**MINUTES  
BOARD OF BUILDING STANDARDS/  
ARCHITECTURAL BOARD OF REVIEW/SIGN REVIEW  
REVIEW MEETING  
CITY OF LAKEWOOD  
12650 DETROIT AVENUE  
AUDITORIUM  
AUGUST 11, 2022  
5:30 P.M.**

**ARCHITECTURAL BOARD OF REVIEW**

**Docket No. 07-42-22 (14501-09 Detroit)**  
**Certificate of Appropriateness – Curtis Block Building**

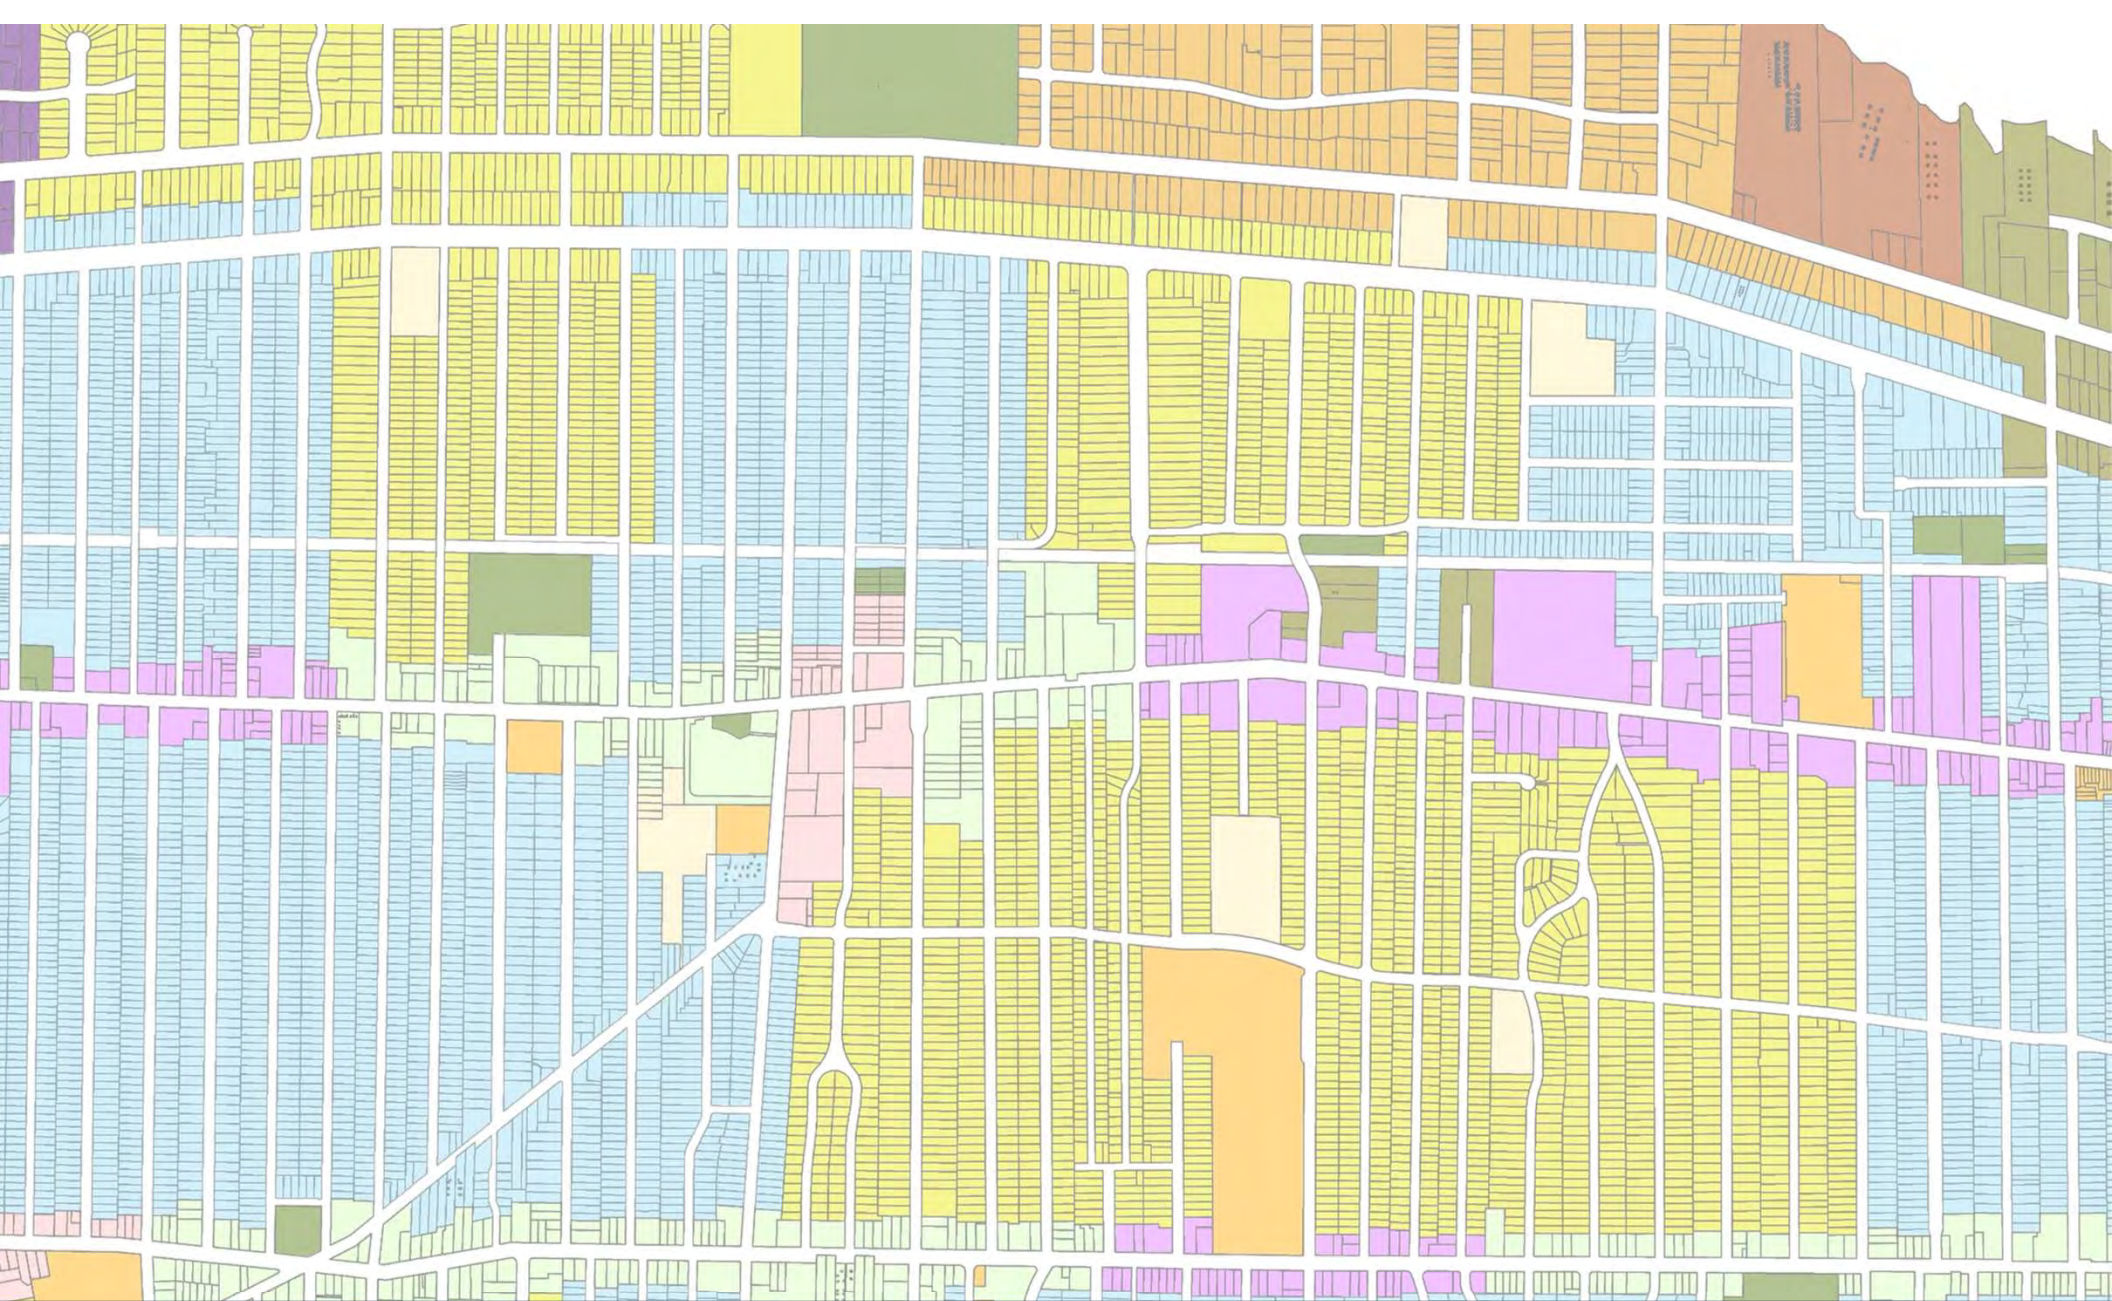
- The presentation on the Curtis Block Certificate of Appropriateness should be organized around – and directly reference – the Standards for Rehabilitation. By specifically citing/highlighting the standards, the applicant can provide their justification on why they believe their proposal is appropriate using the same criteria that the Board is required by code to reference in providing their determination.

- Recommend revising the extent to which Building 1 extends over the Curtis Block – this is related to the Detroit Streetscape comment above. Board noted that the two buildings need to be compatible/integrated – understanding the importance of Building 1 to activating the public space to the west, but also indicating that Building 1 appeared to extend over the roof too far...potentially needs a consistent set-back from the Curtis Block parapet on both the Marlowe and Detroit sides.

**Docket No. 07-36-22 (14968 Delaware)**

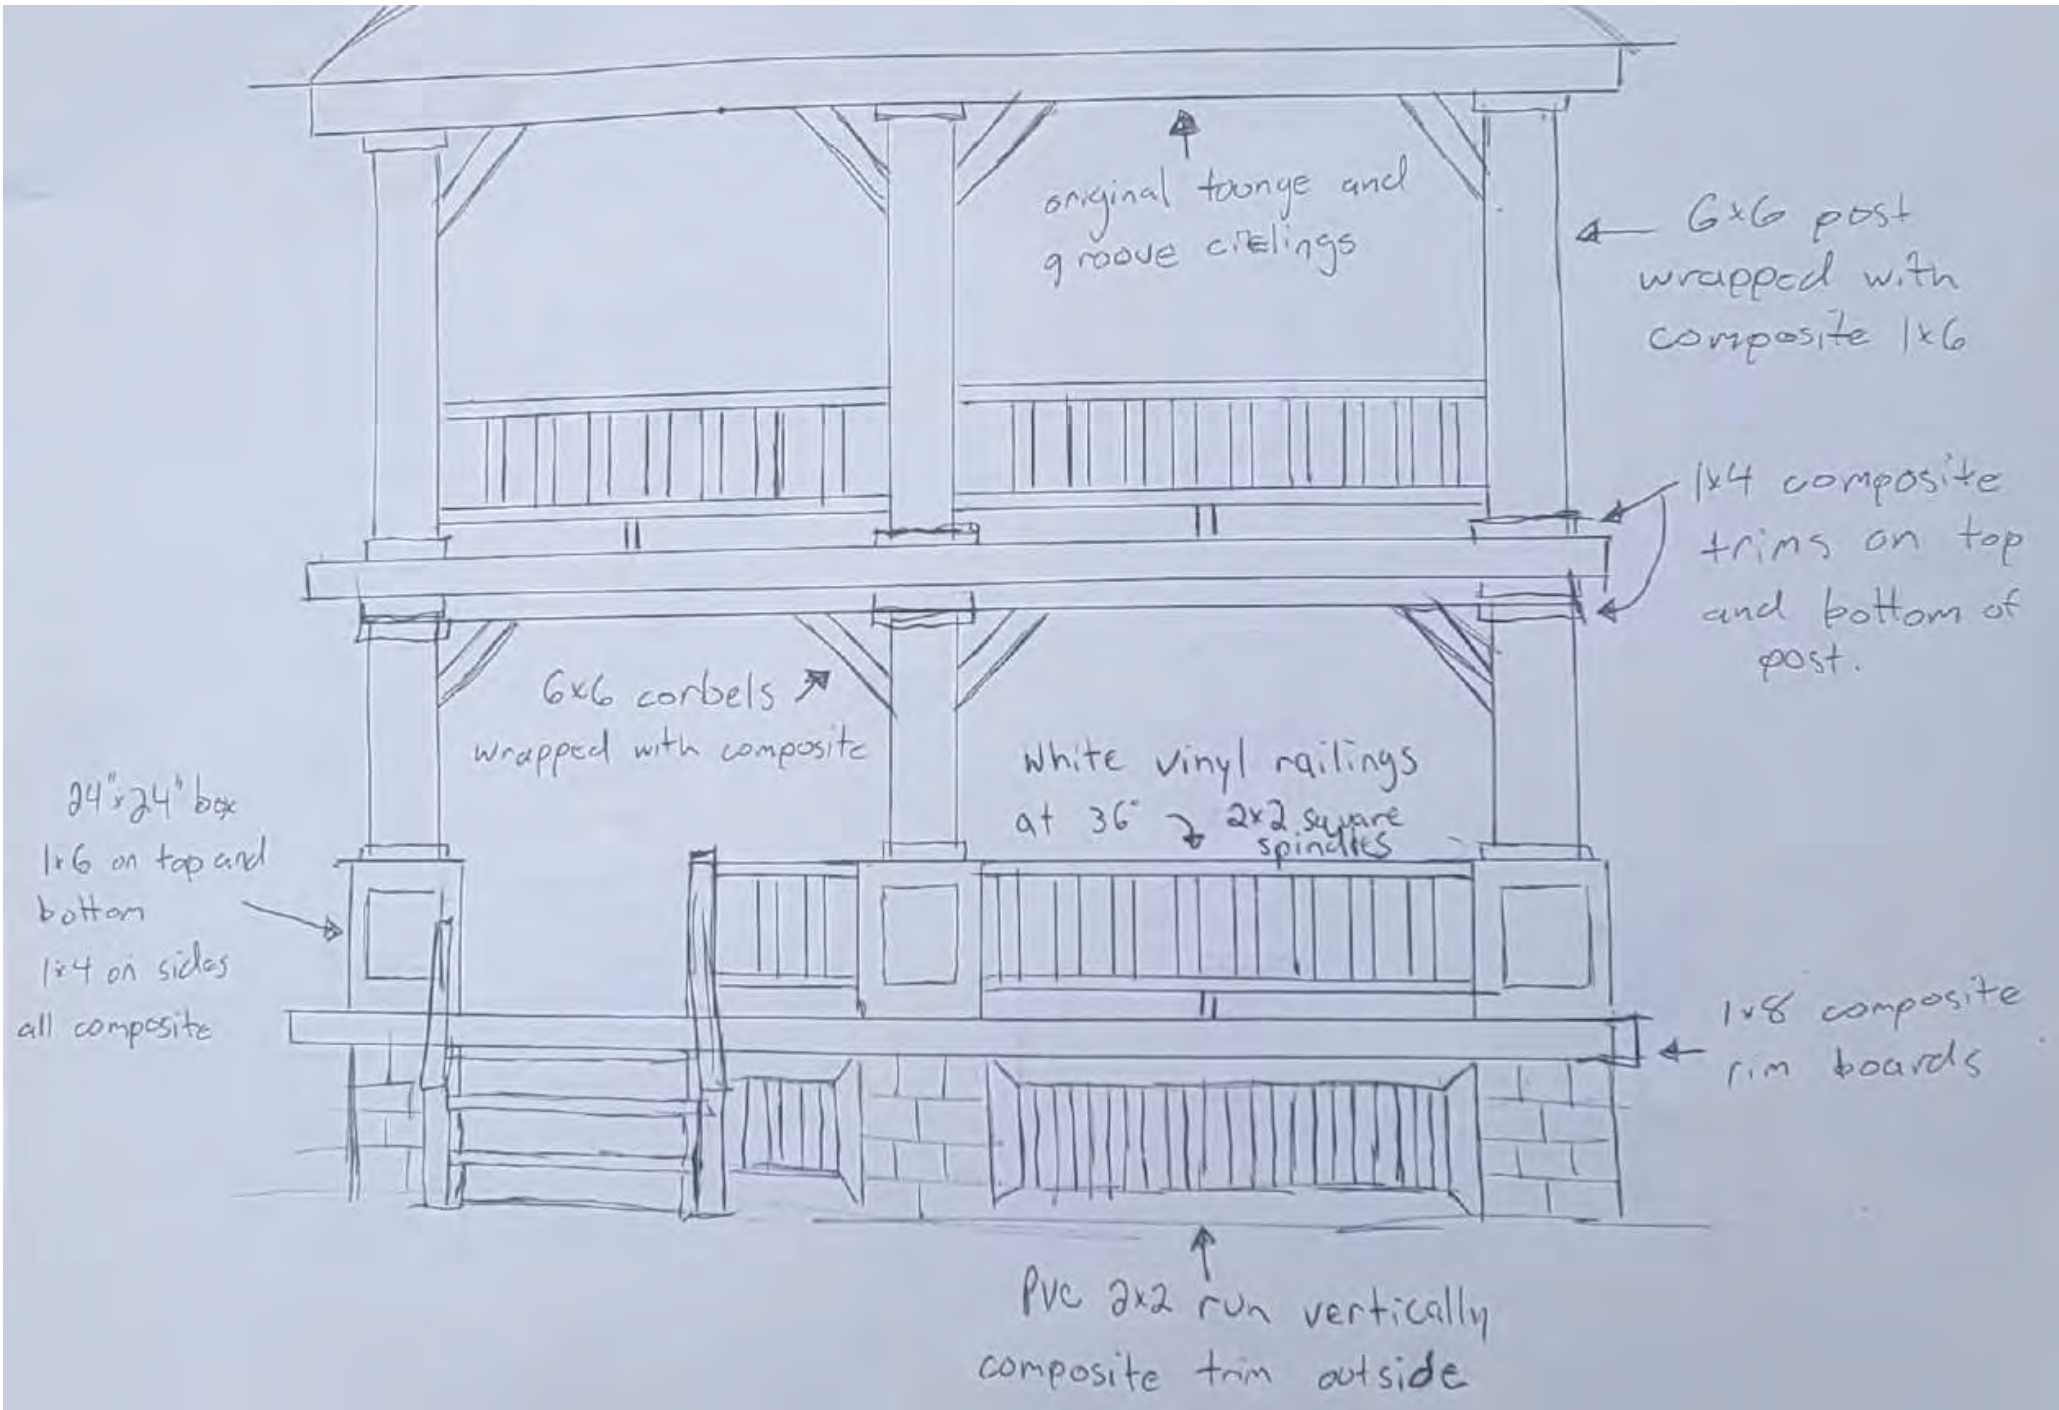
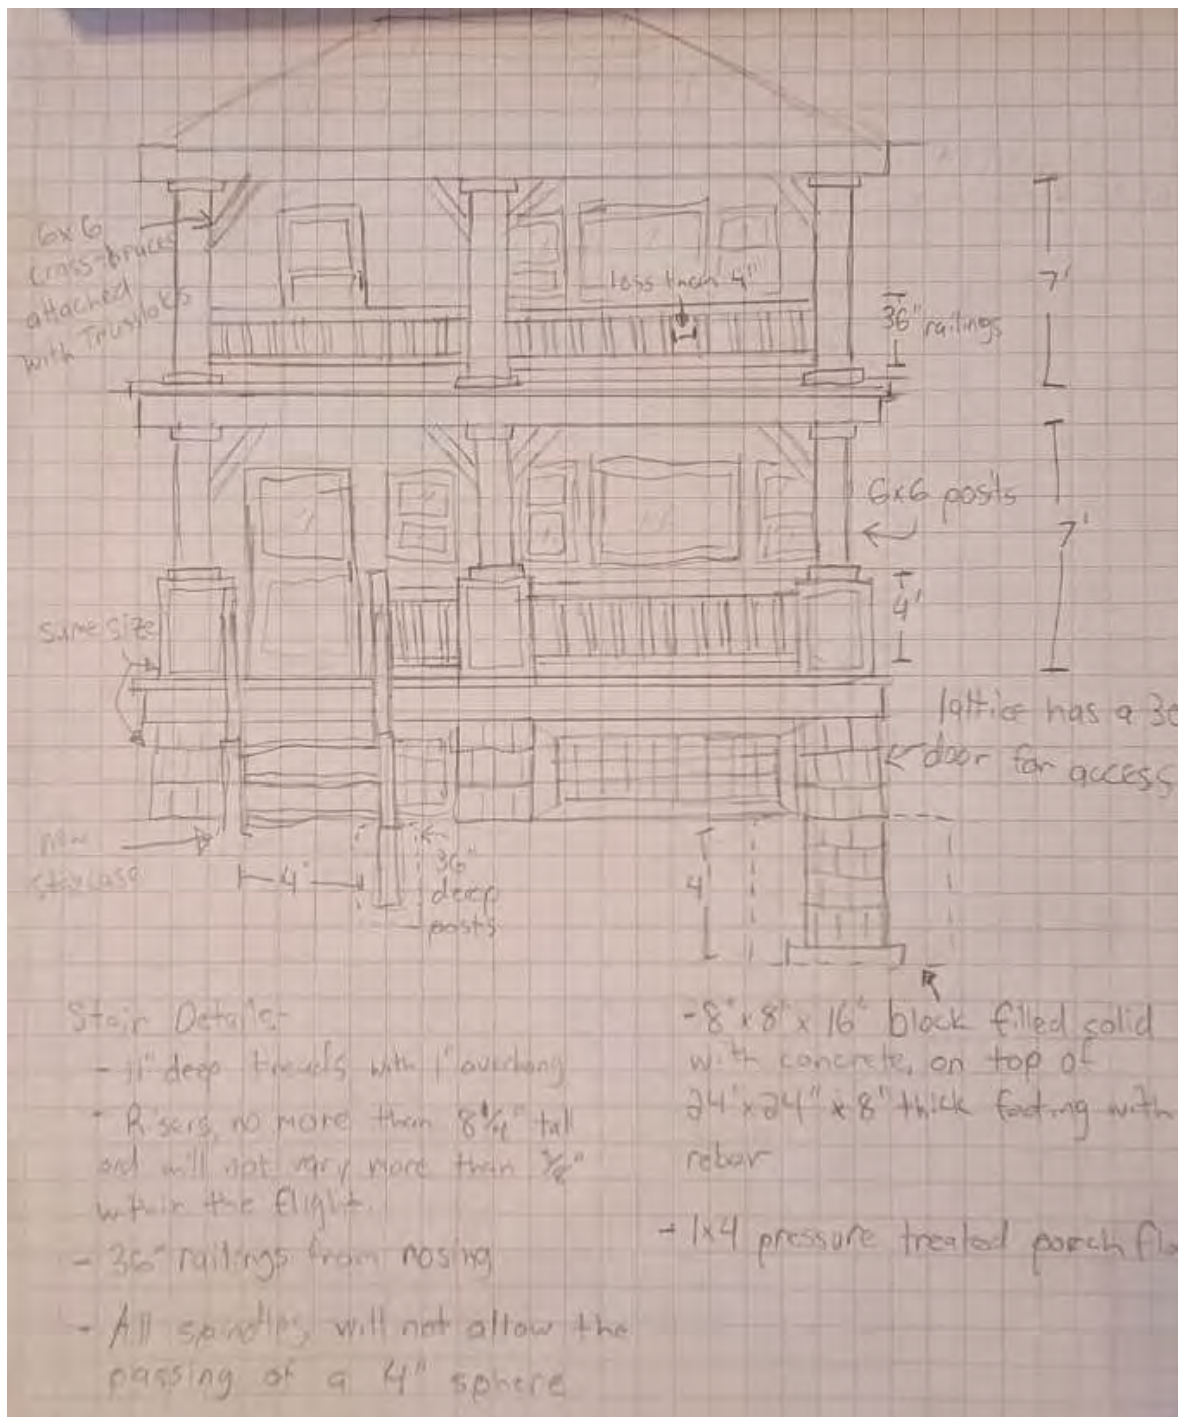
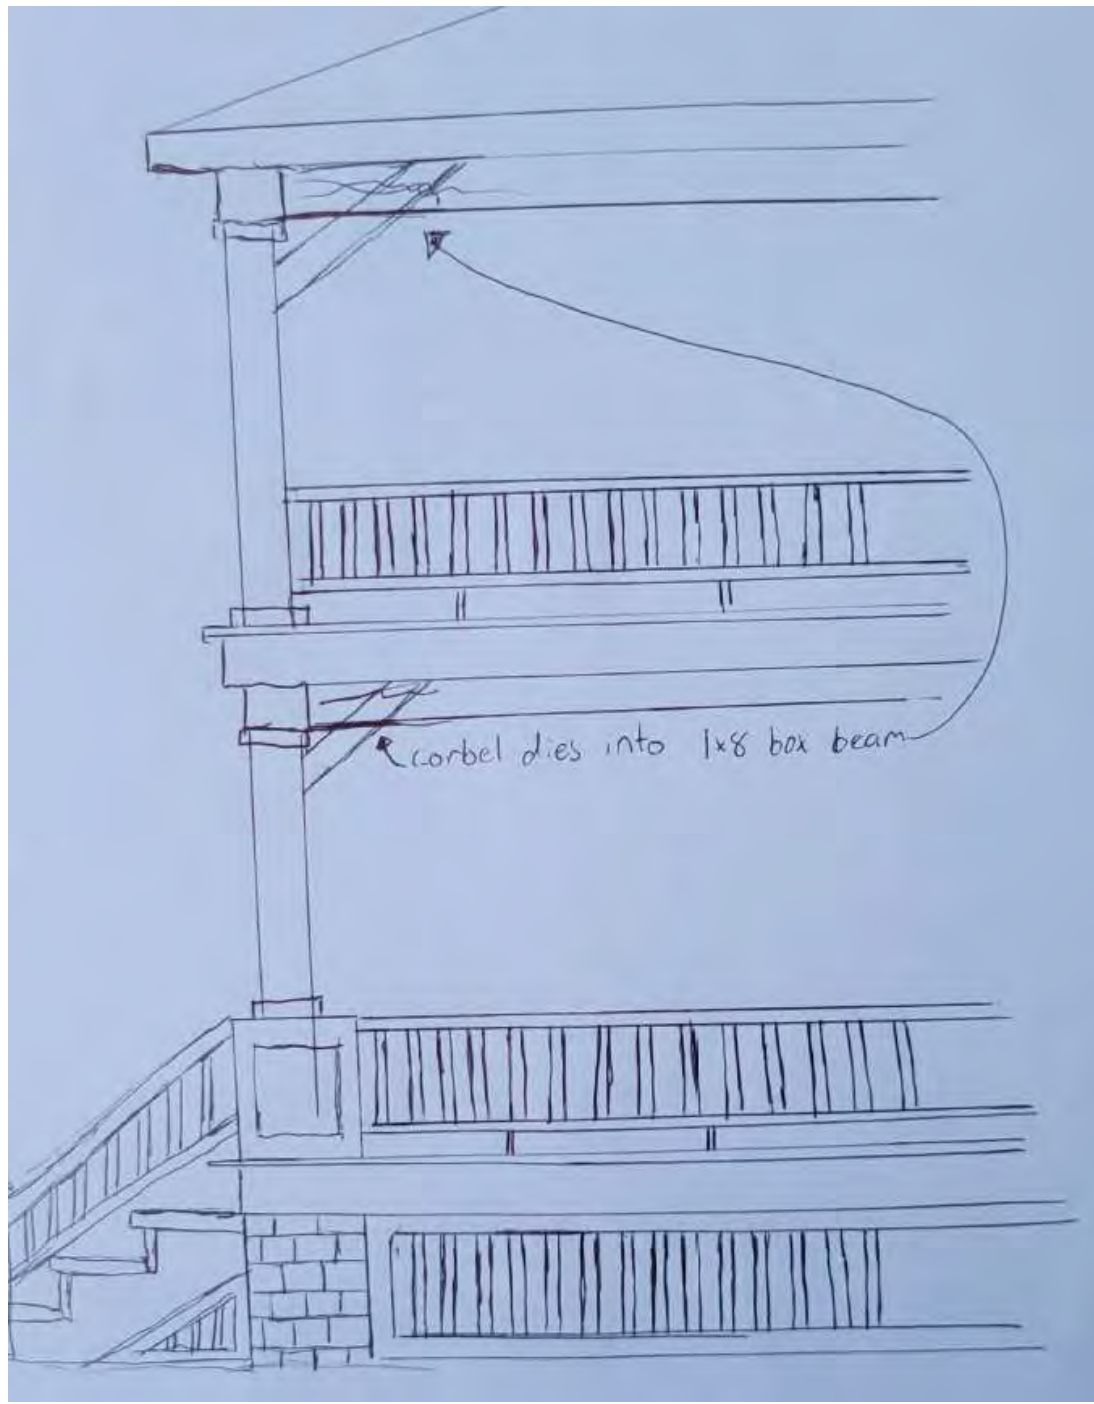
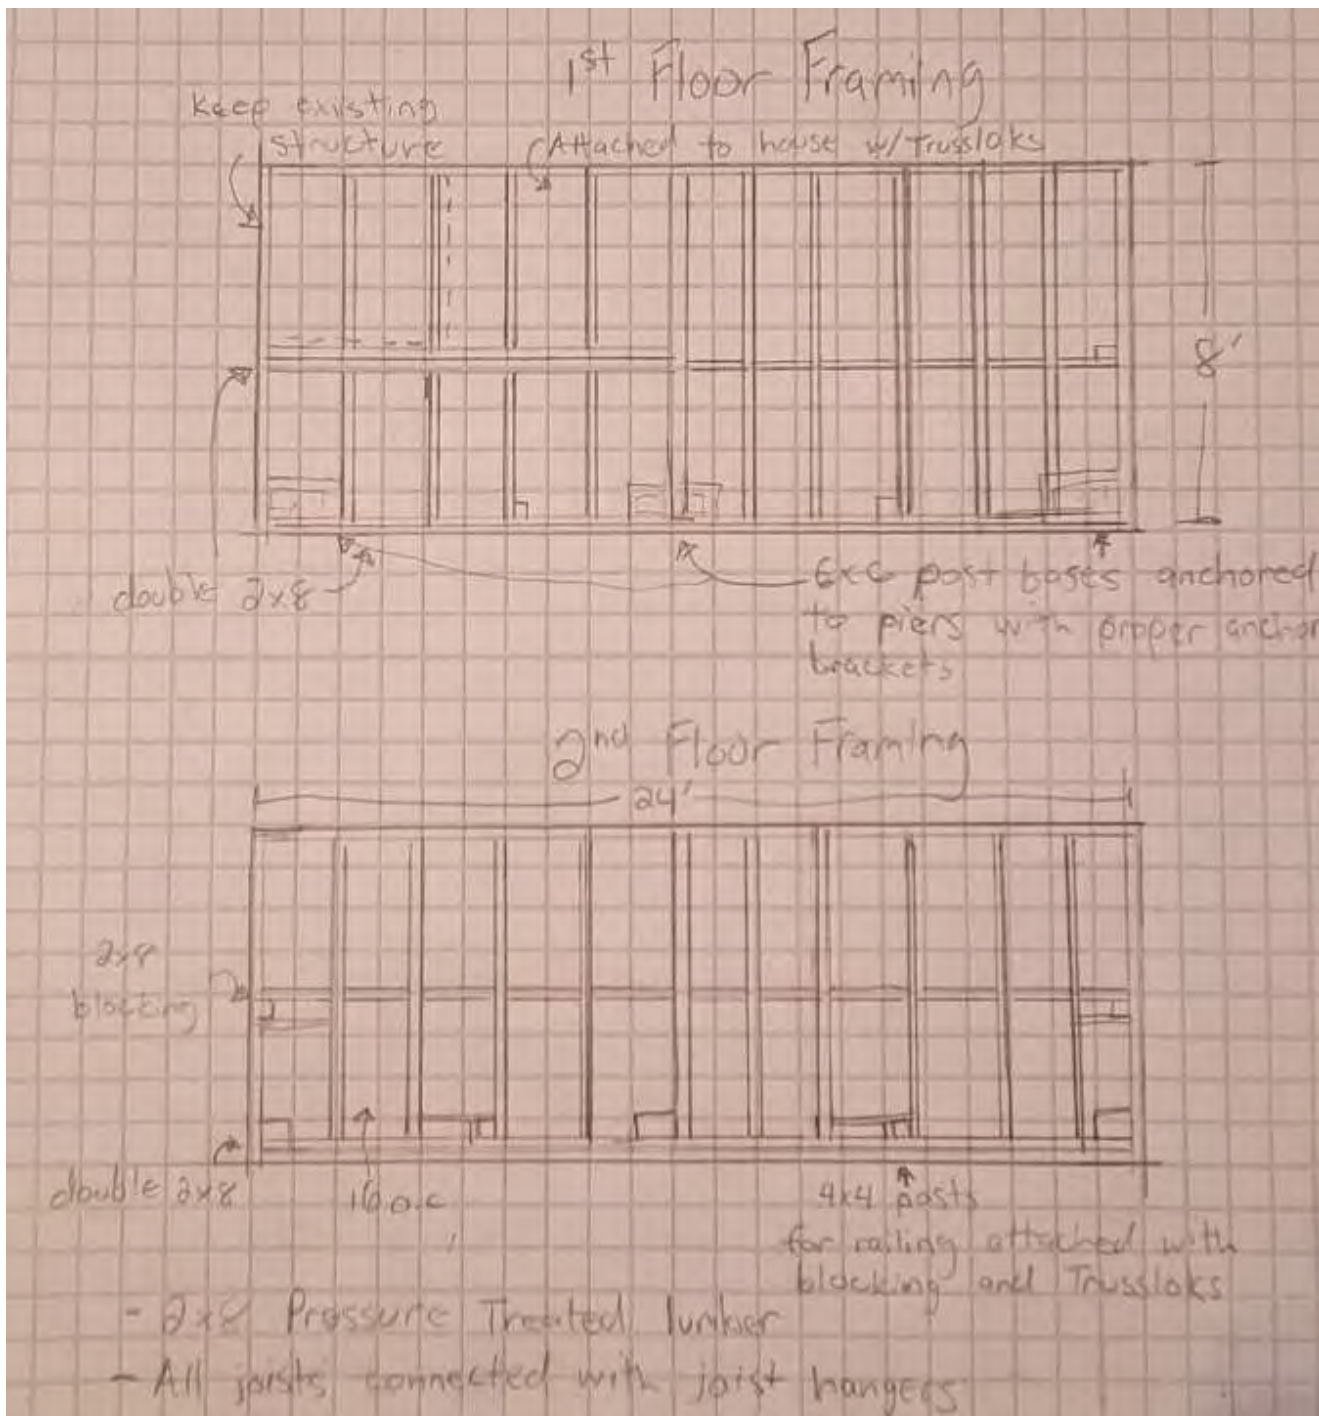
Zach Sword, Claymore Construction Inc., applicant was present to explain the request. There was discussion about the column and pillar dimensions, first floor railing height, shadow box detail, cross braces/corbels, first and second floor band boards, lighting, lattice work, vinyl siding. The members said it will be a nice improvement. Staff was happy to see the porches returned to the original style. Public comment was closed as no one addressed the item. Staff do not receive any communication.

- **There will be no corbels (a Simpson bracing system will be investigated).**
- **The bases will be three feet high, and two-by-two feet wide.**
- **The six-inch-by-six-inch posts will be boxed to approximately 12 X 12 inch square columns.**
- **The lattice will be vertical, two-by-two style.**
- **Railings end into a solid trim board vertically where they connect to the house.**
- **Vinyl siding to match where removed for construction.**
